Diganta Sweater Ltd. Tricotex Sweaters Ltd. Sweaters Zone Ltd.

Naoujoor, Tangail Road, Chandana,
Chowrasta, Gazipur - 1702
(23.988488N,90.365998E)

01 April 2014

Observations

Building 1 Level 2

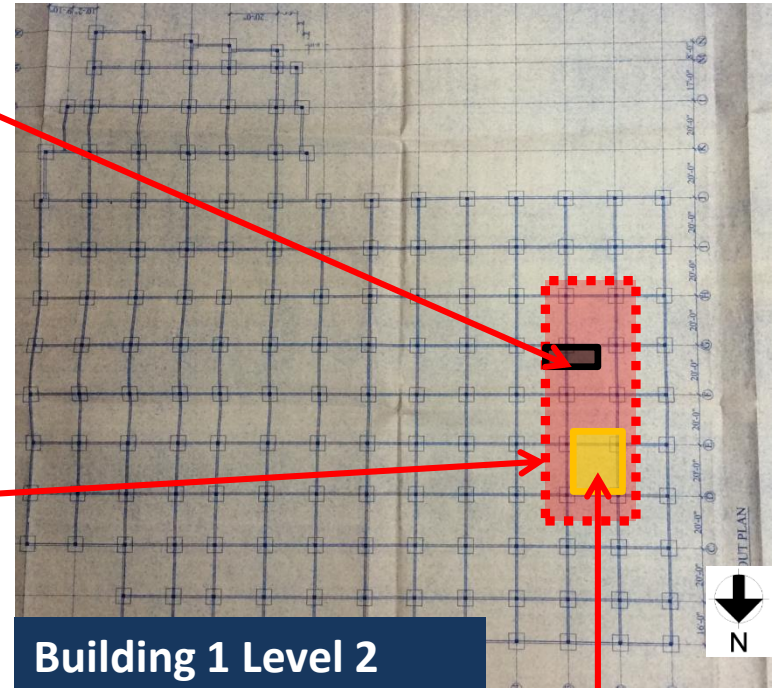
Design check required for floor build-ups and toilet areas Buildings 1 and 2

170mm high floor build-up in toilet area supported by concrete slab and beam arrangement.

Building Engineer to verify that the columns, slabs and beams have been adequately designed to carry floor build-up loads

Building Engineer to verify that the columns, slab and beams have been adequately designed to carry floor build-up loads

**75mm floor built-up on
60mm floor built-up**

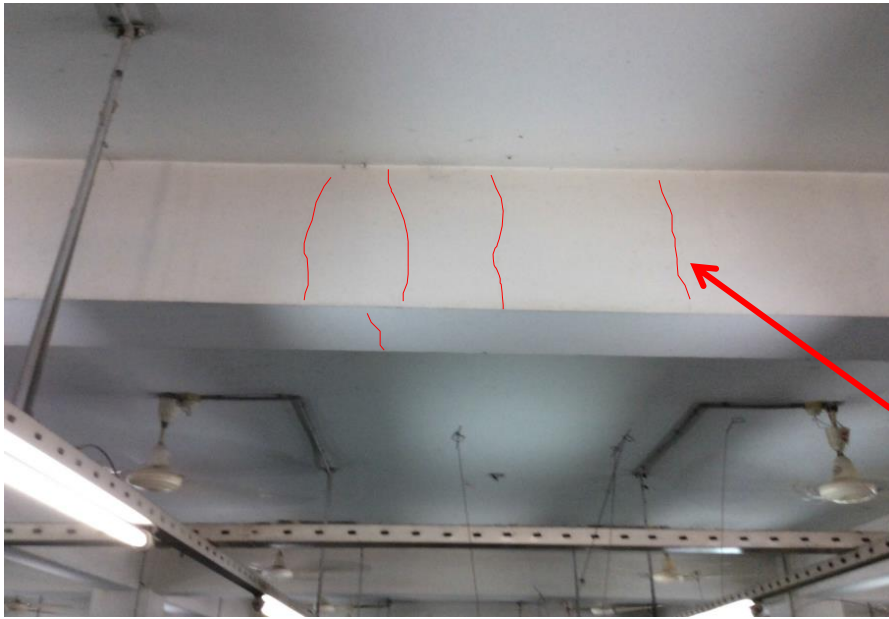
Design check required for columns supporting water tanks in Buildings 1 and 2

Building 1 water tanks located at corners of the building.

Building Engineer to verify that the columns supporting the tanks have adequate carrying capacity

Building 2 water tanks located at corners of the building.

Building Engineer to verify that the columns supporting the tanks have adequate capacity

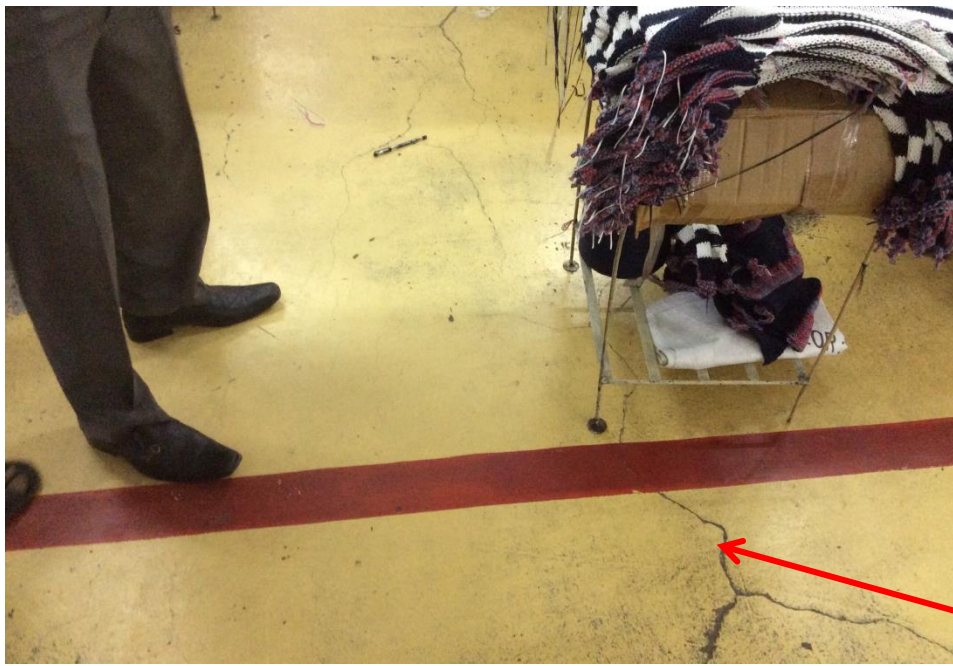
**Hairline cracking observed on soffit
and sides of beams at all levels of
Buildings 1 and 2**

Typical non-structural parallel cracking at mid-span of beam, and random cracks near support. The cracks are more widespread at the underside of the roof.

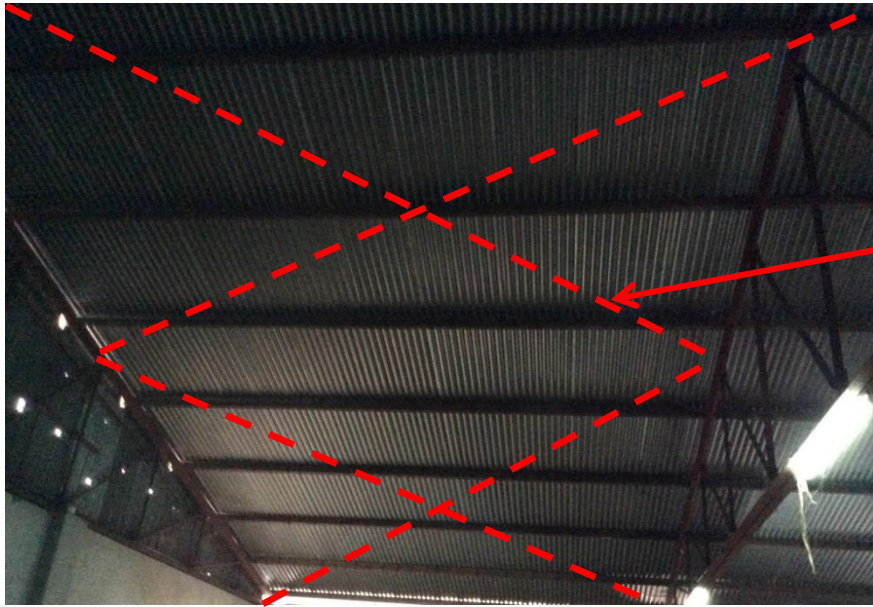
**Cracking observed on the floor
finishes at all levels where concrete
screed was used**

Cracking observed on the floor finishes at every level. It appear that these are superficial as there are no evidence that cracking is extending to slab soffit and there is no cracking to tiled areas of the slab.

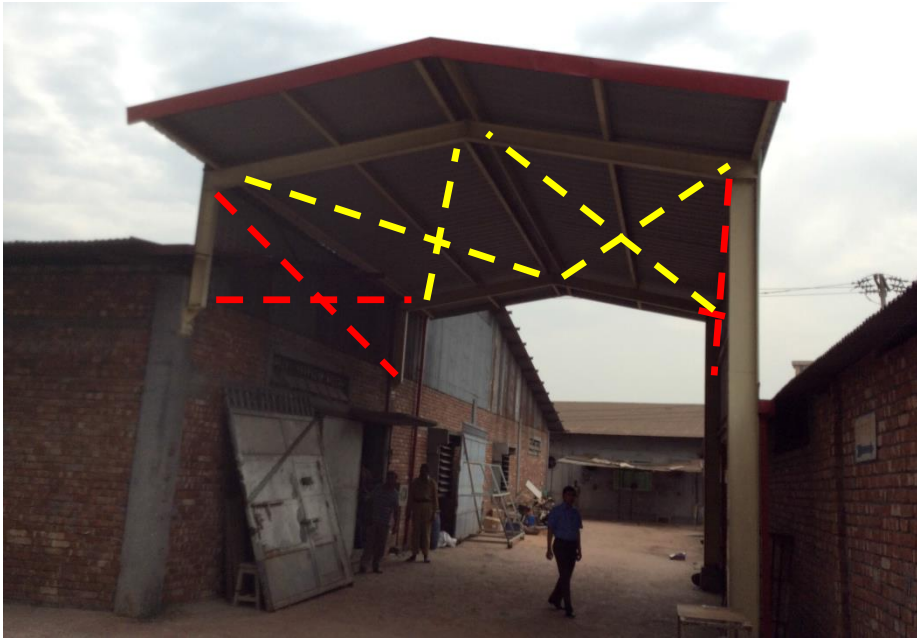
No roof bracing provided for sheds

No
horizontal
bracing

Design check required for
lateral stability

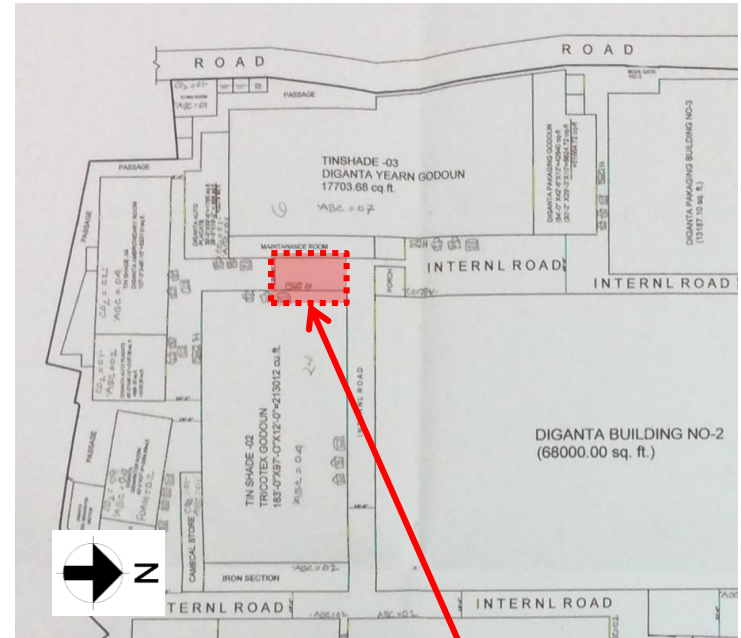
No bracing

No bracing provided to the portal frame for stability.

Building 3

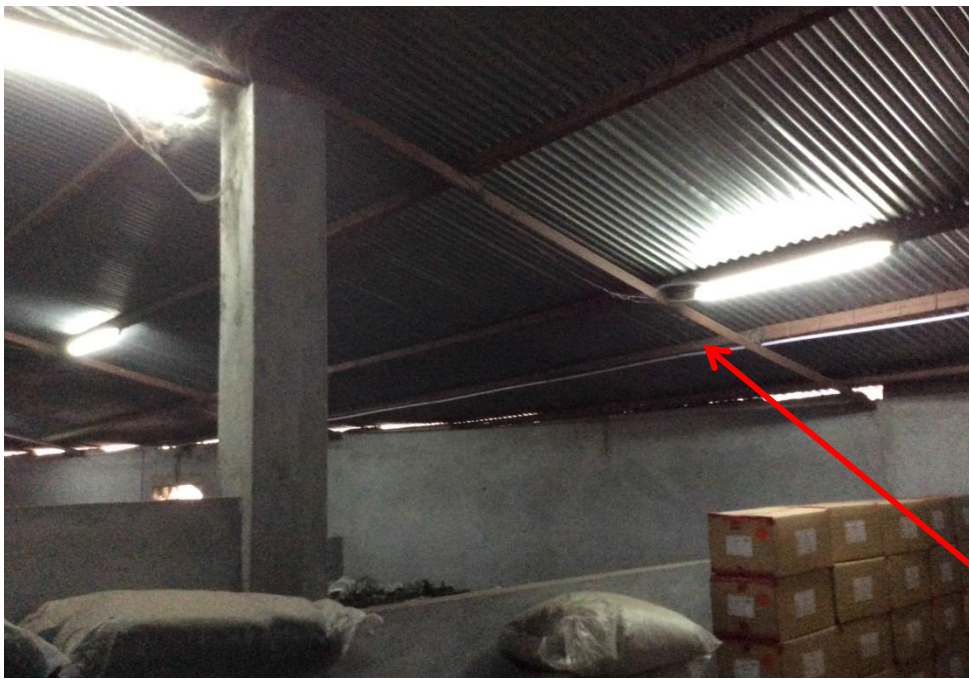
Deflections in existing roof structure

Rafter deflecting excessively

Rafters provided in Building 3 extension appear too small. Review and replace if necessary with suitable steel section.
